TECHNICAL BULLETIN

412-17-240

**MODEL AFFECTED:** 412/412EP

**SUBJECT:** HYDRAULIC SYSTEMS #1 AND #2 ACCUMULATOR  
P/N 212-076-007-003, REMOVAL OF

**Figure 1**  
 Hydraulic System I Pre TB 412-17-240 Configuration

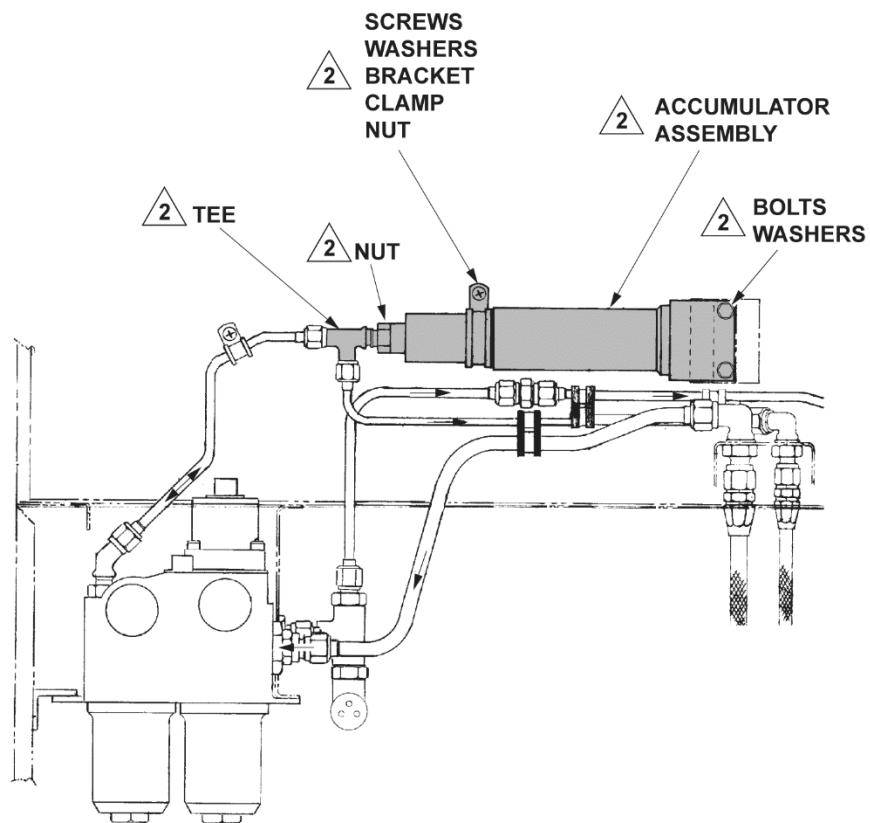
1. Prepare helicopter for maintenance.
2. Gain access to both hydraulic accumulators (BHT-412-MM-2).
3. Remove all parts shown in grey on Figure 1, 2 and 3 as applicable (BHT-412-MM-4).

- 1 Retain parts for relocation.
- 2 Parts no longer required.

**Figure 2**  
Hydraulic System II Pre TB 412-17-240 Configuration

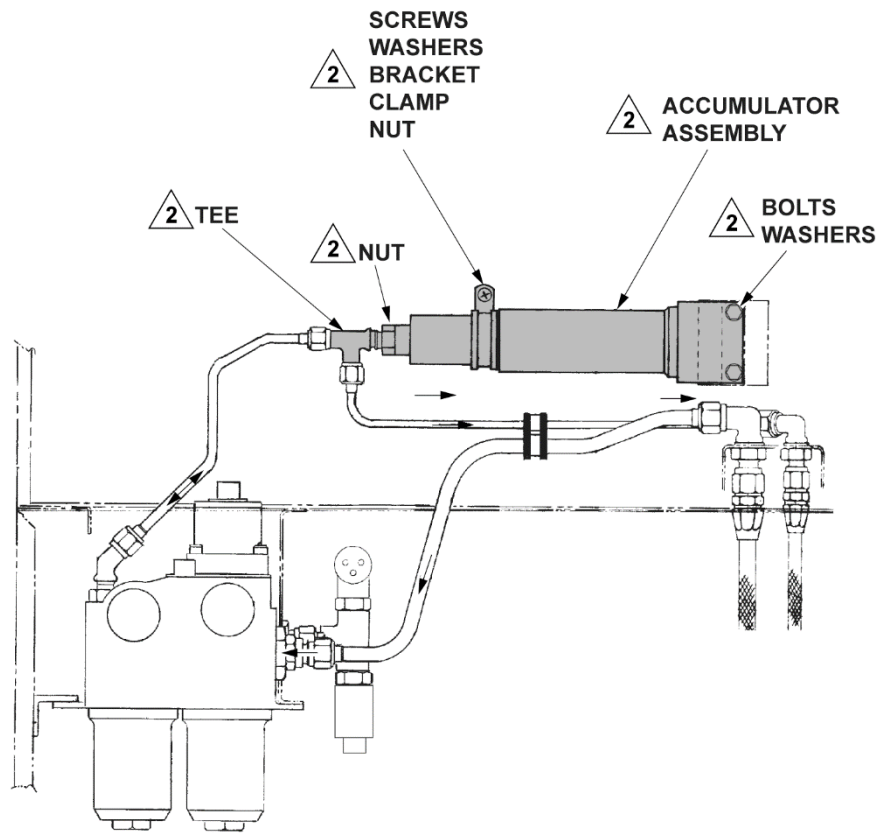
2 Parts no longer required.

**Figure 3**  
 Pre TB 412-17-240 with EPI STC  
 36550,36562,36612,36614,36648,36649,36658 and 36659

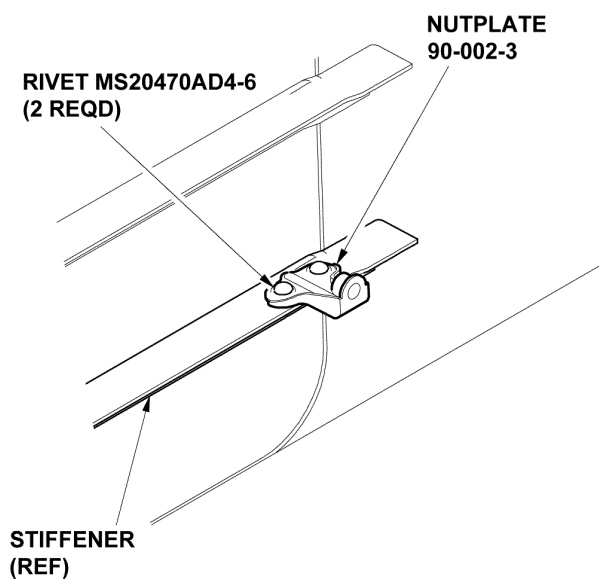
Parts no longer required.

**Figure 4**  
Modification  
36694 and Subs

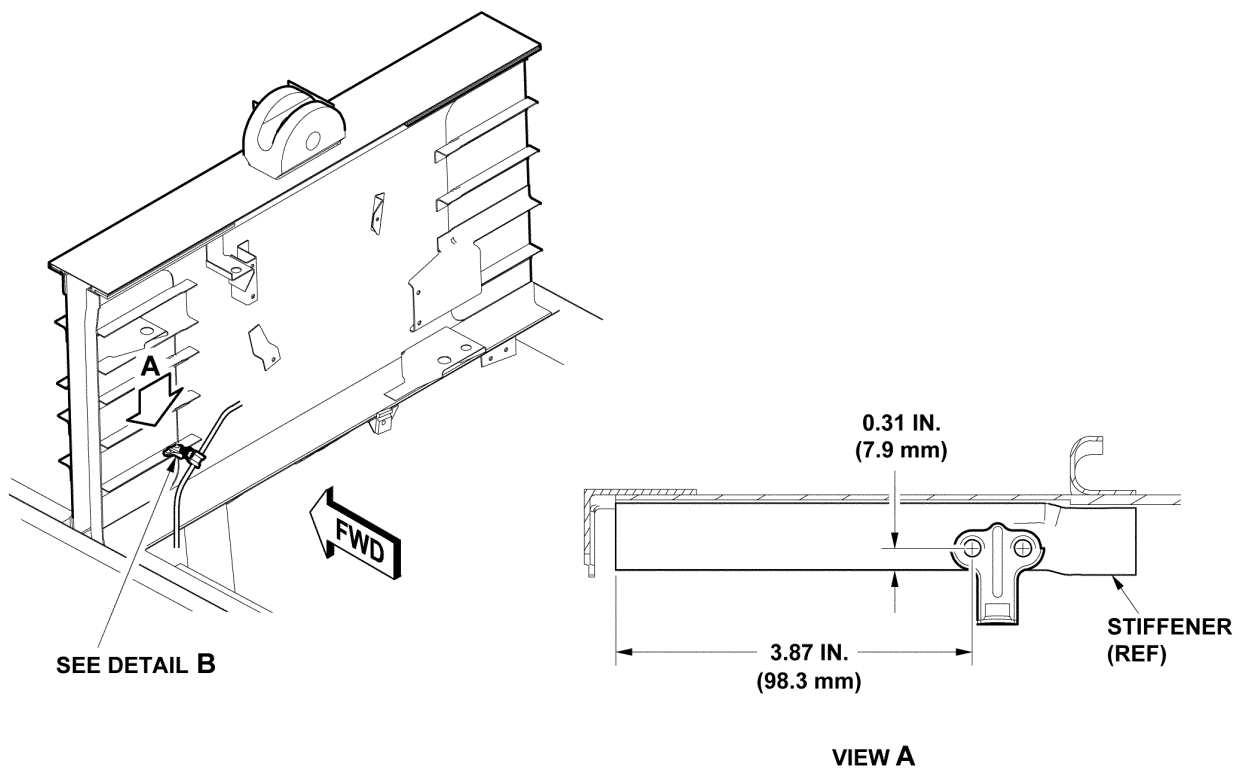
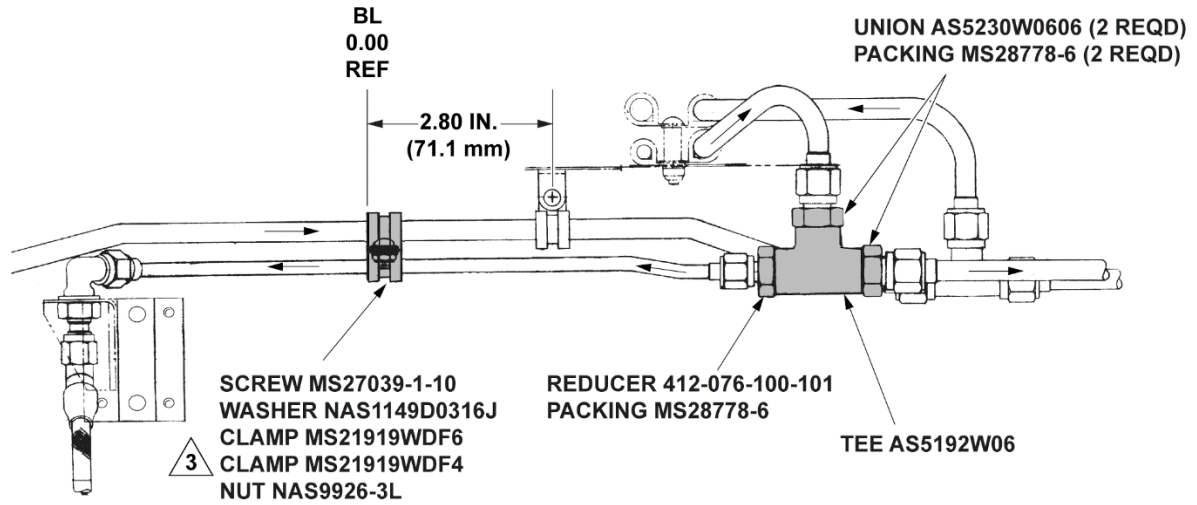
4. Install Nut plate 90-002-3 shown on Figure 4 as follow:
  - a. Install clamp MS21919WDG4, screw MS27039-1-10, washer NAS 1149DO316J with spacer NAS43DD3-12N and nutplate on tube assembly P/N 212-076-571-001. Do not tighten screw at this time to allow proper positioning of nutplate.
  - b. To prevent tube and stiffener preload, temporary install tube to fit and locate the nutplate on stiffener P/N 205-030-845-376 (Detail B) mark position of the nutplate and remove tube assembly.
  - c. Install the nutplate 90-002-3 using rivets MS20470AD4-6 (of the proper length), to the lower left hand stiffener P/N 205-030-845-376.
  - d. Touch up the area, as required, with primer C-204 (BHT-ALL-SPM).

**Figure 5**  
Hydraulic System I Post TB 412-17-240

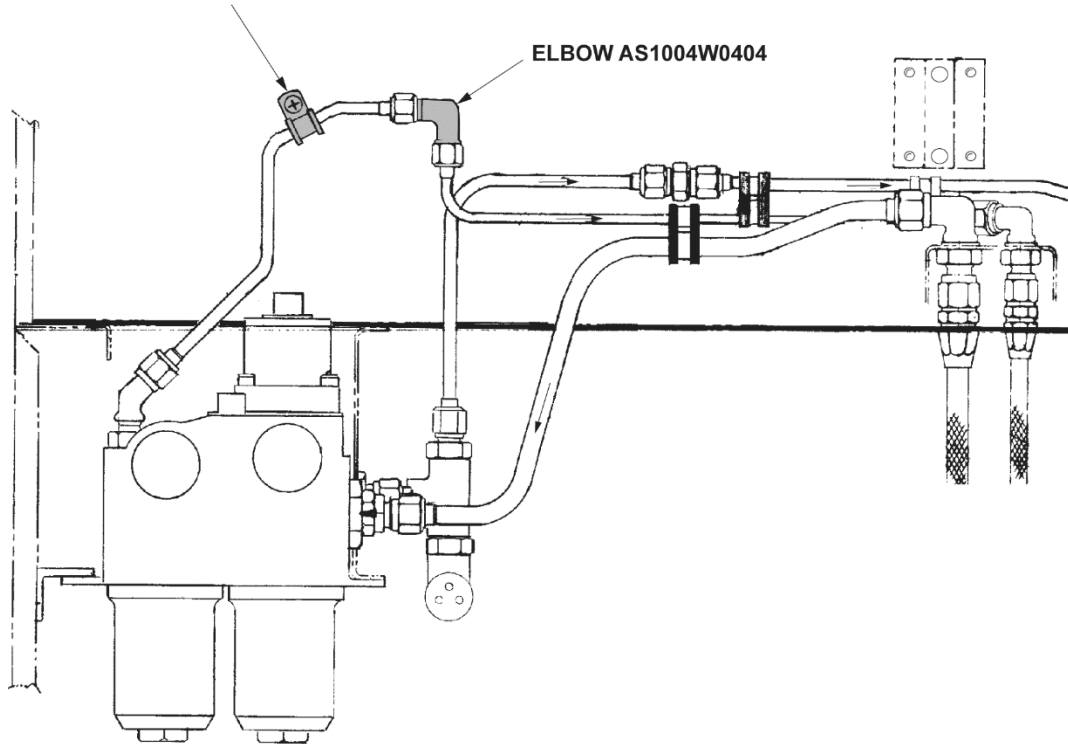
5. Install new hardware shown in grey on Figure 5,6 and 7.
6. Make an entry in the helicopter logbook and historical service records indicating compliance with this Technical Bulletin.

3 Relocate clamps and hardware 2.80 inches (71.1 mm) away from center of bracket.
